**MEMORANDUM**

**Re: Shepherdstown Opera House Renovation**  
ADDENDUM No. 4

The following information amends or supersedes the current issue of architectural, structural, and MEP drawings/specifications dated June 22, 2020 and addendums #1, #2 and #3.

A-SK  
3

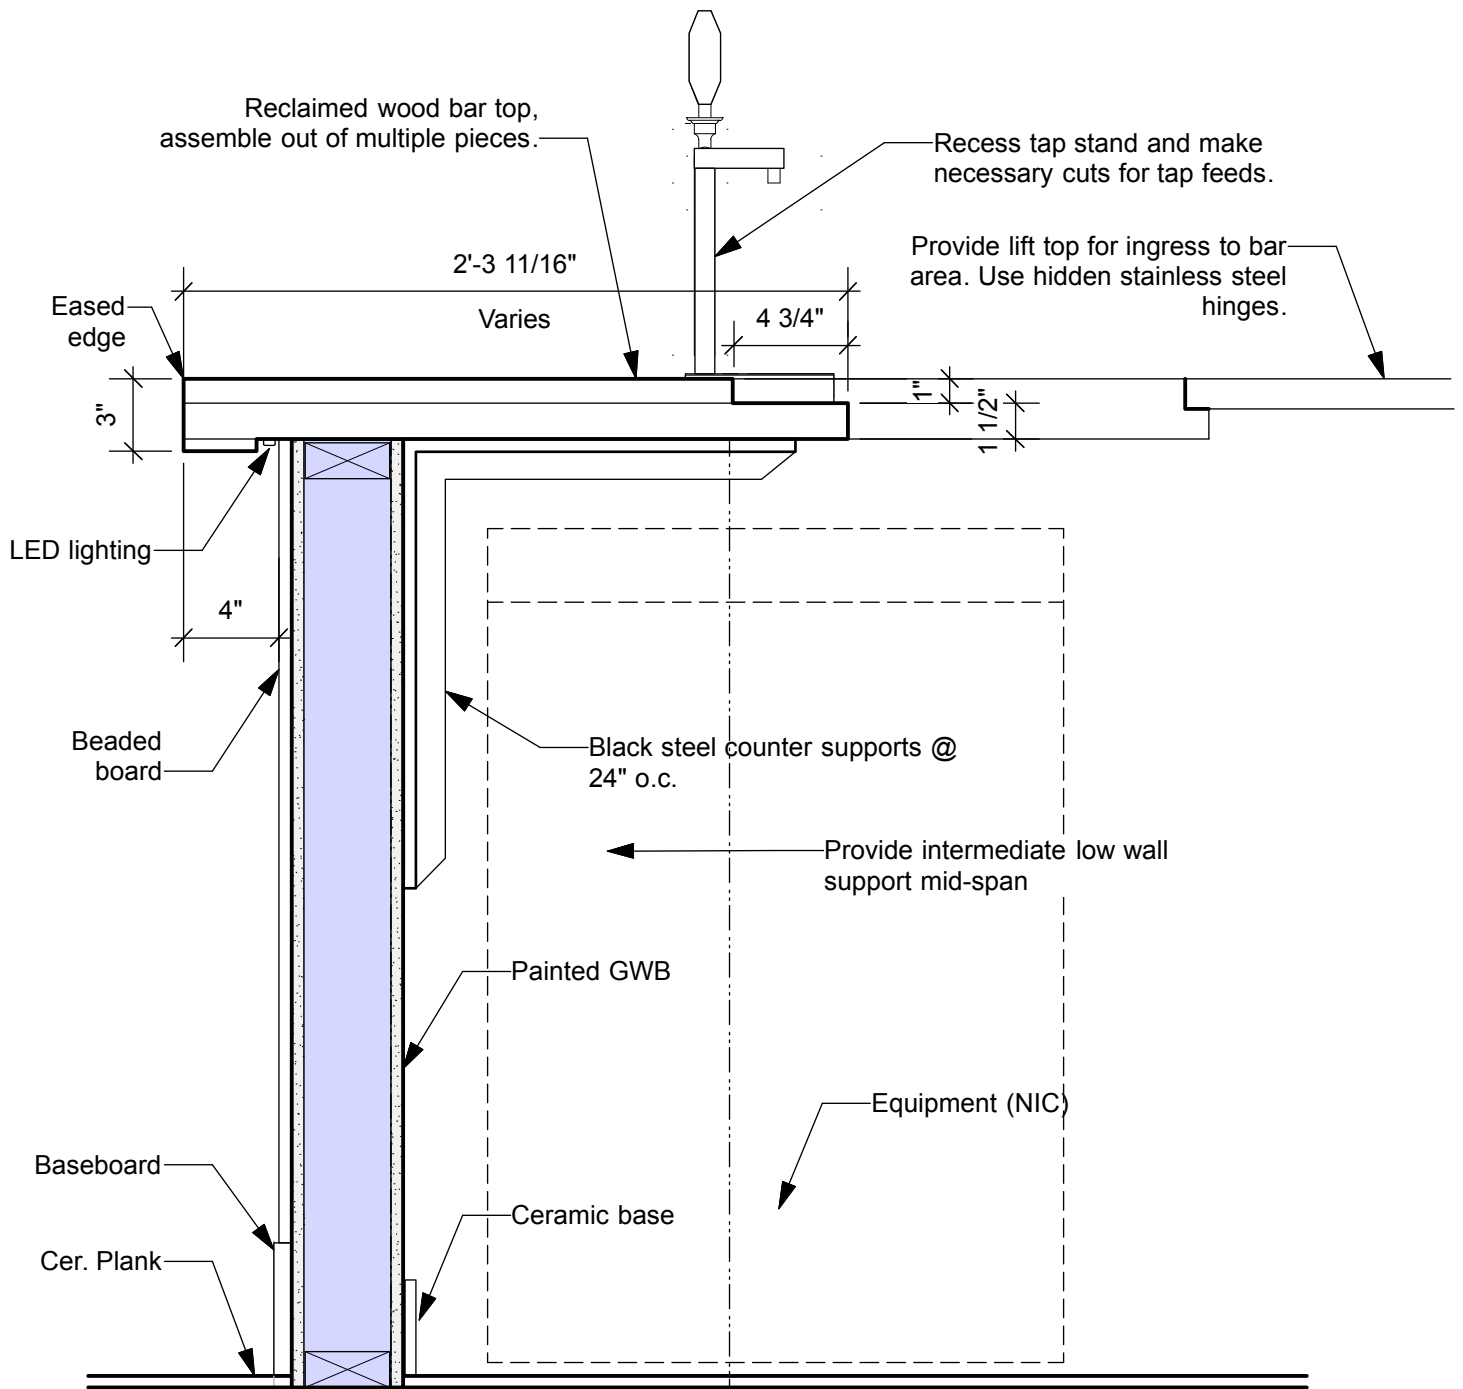
8. See ASK-3 Bar Section for details on the reclaimed wood bar.
9. Substitutions must be submitted with specific model numbers.
10. The general contractor is ultimately responsible for installation of condensate drains and should decide which trade does the installation.
